Takes of Marine Mammals Incidental to Specified Activities; Taking Marine Mammals Incidental to an Exploration Drilling Program in the Chukchi Sea, Alaska

ACTION: Notice; issuance of an incidental harassment authorization.

SUMMARY: In accordance with the Marine Mammal Protection Act (MMPA) regulations, notification is hereby given that NMFS has issued an Incidental Harassment Authorization (IHA) to Shell Gulf of Mexico Inc. (Shell) to take marine mammals, by harassment, incidental to offshore exploration drilling on Outer Continental Shelf (OCS) leases in the Chukchi Sea, Alaska.

Figure 1. Source levels in 1/3-octave bands for the drillship Discoverer and ice management surrogate vessel (the ice handler Maersk Rover).

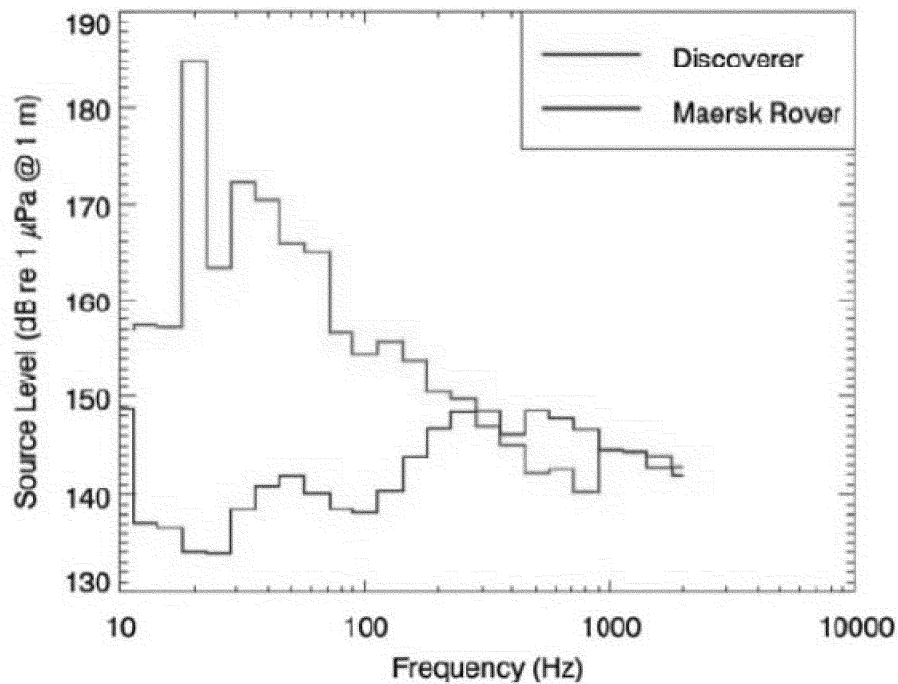
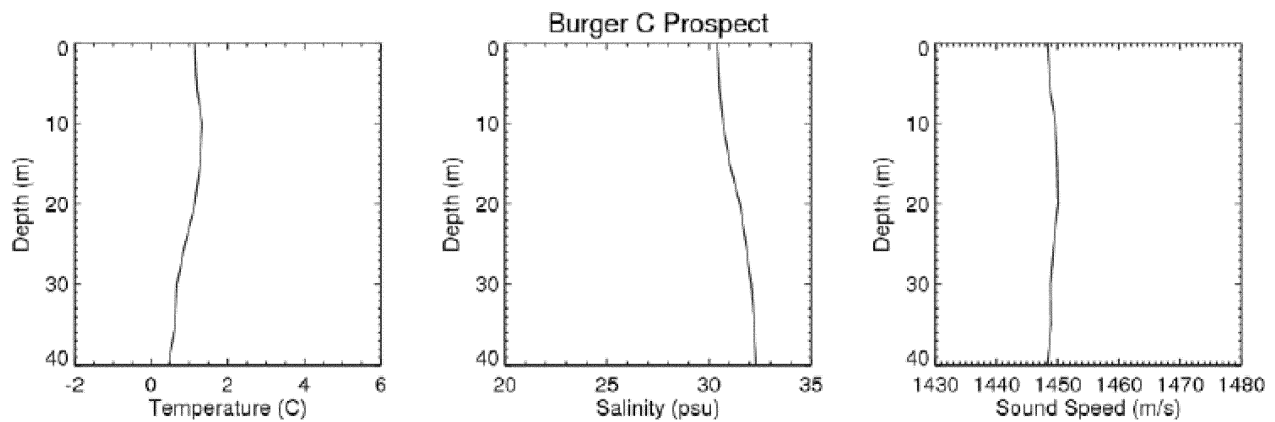
Comment 26: The MMC states that it is not clear which specific source level was used to model the size of the corrected 120-dB re 1 μ Pa harassment zone for the *Discoverer*, as the reported source levels for the *Discoverer* ranged from 177–185 re 1 μ Pa at 1 m. It also is not clear how the source level measurements taken in the South China Sea were incorporated in the model to estimate the 120-dB re 1 μ Pa harassment zone in the Chukchi Sea.

Comment 27: Dr. Bain notes that sound propagation efficiency depends on conditions and that the modeling used by Shell does not capture the most efficient mode of propagation. He also states that there is great uncertainty with source levels based on single measurement locations, as was done for the *Discoverer*.

Response: The modeling analysis considered 1/3-octave band levels to account for frequency-dependent propagation effects that cannot

adequately be characterized with broadband analysis. The 1/3-octave band source levels were obtained from dedicated measurements of the *Frontier Discover* (now *Noble Discoverer*) during drilling activities in the South China Sea. A plot showing these levels is provided in the response to *Comment 27*, and the corresponding broadband levels could be computed by summing those if required. The modeling approach applied by JASCO Applied Science was the MONM parabolic equation acoustic propagation model in each 1/3-octave band from 10 Hz to 2 kHz. The resulting received band levels were summed to compute the broadband received levels at many depths, distances and directions from the planned drillship location. Representative sound level threshold radii were determined by calculating the 95th percentile distance, over all azimuths, at which the maximum threshold over all depths was received. This approach considers that animals may sample multiple depths as they pass by the drilling operation.

Response: The concern raised here about variability of profiles is addressed in the response to *Comment 29*. With regard to the question on which source levels were used for modeling, this study considered 1/3-octave band source levels from the *Discoverer* drillship obtained during dedicated measurements performed in 2009 in the South China Sea (Austin and Warner, 2010). The specific levels are representative of the drilling operation since that activity will occur for the majority of time. The source levels used

Figure 4. Band levels for the Discoverer during drilling.

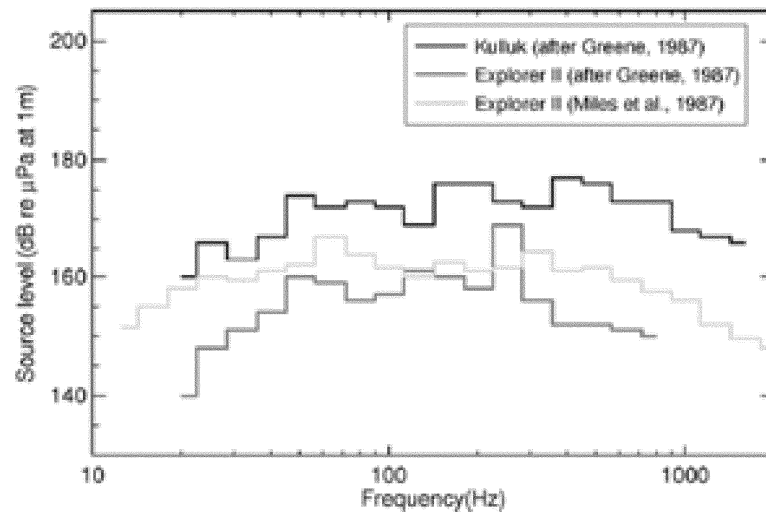
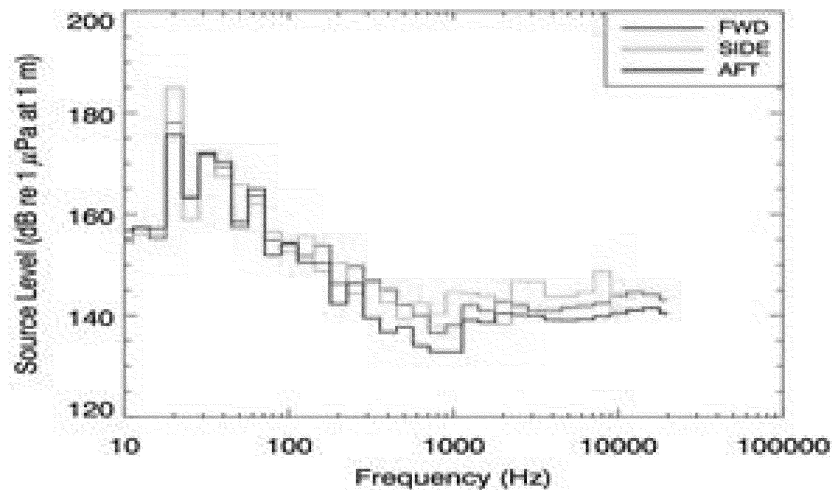
Comment 37: The NSB and AWL note that the modeled 120-dB isopleths for the *Discoverer* are different in the Beaufort and Chukchi Seas (with the isopleth being slightly smaller in the Chukchi Sea). Additionally, they question if the 120-dB isopleth for the *Discoverer* is correct given its nearly identical source level to the *Kulluk* drill rig (proposed for use in the Beaufort Sea), for which sound propagates out to the 120-dB isopleth at a much farther distance. If the modeled propagation is incorrect for the *Discoverer*, then this would bias the take estimates low.

Response: The primary reason for the difference in the distance of the 120-dB isopleths for the *Discoverer* in the Beaufort Sea vs. the Chukchi Sea is due to differences in the geoacoustic parameters for the two seas that were input to the model. Water depth, seabed density, and seabed sound speed are generally the most important parameters that influence sound propagation.

Differences in sound propagation from the two rigs are real and are caused by differences in the design of the two vessels. While the broadband source levels for the *Discoverer* and *Kulluk* may be similar, their spectral properties differ considerably. Acoustic modeling considers the source levels in 1/3-octave frequency bands. Figures 3 and 4 show the band levels for both drillships during drilling. Of key importance are the significantly lower levels of the *Discoverer* in the 50 to 500 Hz bands that propagate well in the relatively shallow waters of these drilling operations. While the *Discoverer* apparently has higher band levels below 50 Hz, this energy is more rapidly attenuated than higher frequency sound energy. This characteristic of sound propagation in shallow waters leads to predominantly mid-frequency sounds (50–500 Hz) dominating the acoustic field at distance from the drillships. A further consideration is that the *Kulluk* source levels are known to include contributions from support vessels, and much of the mid-high frequency band
